# Response to Submissions

# Gerroa Sand Quarry

January 2026

Figure 3  
APPROVED TRANSPORTATION ROUTES

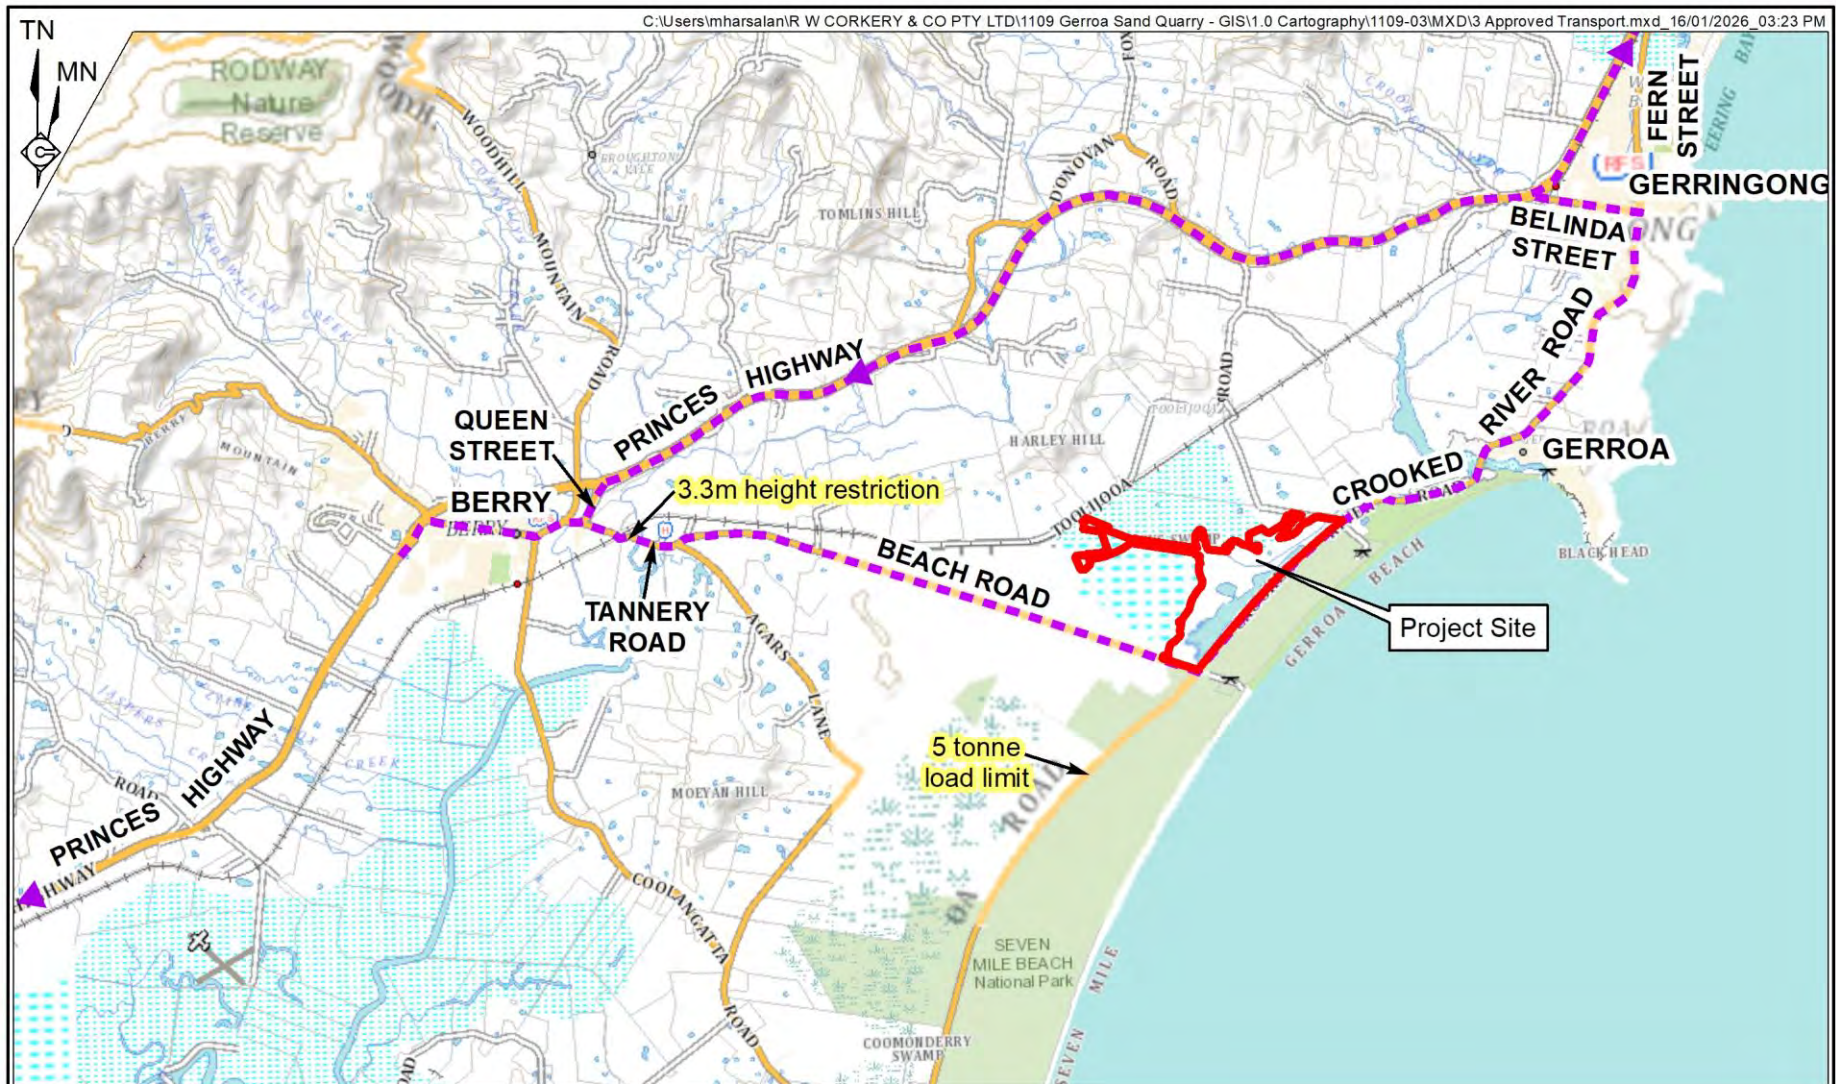
b) Alternatively, based on the transportation route stipulated by management procedures (Ref: QEMP. 27/6/23; Pp6-18; P6-19), and Fig 3 (Mod Report P12), the vast majority of truck movements north and south are directed through Gerringong and Gerroa as the approved route. Consequently, the Proposed Modification would result in a **truck movement in the order of every 17 minutes through Gerringong and Gerroa to the north**. (see ii. below)

I am also concerned that road damage is a community cost that will be aggravated, should this modification be approved. The approved transportation routes shown in Figure 3 of the report include sections of Crooked River Road and Beach Road that are suffering almost constant damage. The primary contributor to this damage appears to arise from adverse weather events, however increasing the structural impact from heavy vehicles by 50% will only increase this damage and consequent community cost. The report takes the approach that impact is localised to the site, however the cost borne by the community and the environment is far wider.

The Proposed Modification does not propose any change to maximum vehicle sizes, number and timing of traffic movements or how vehicles access, move within and leave the Quarry and there would be no change to the existing transport routes.
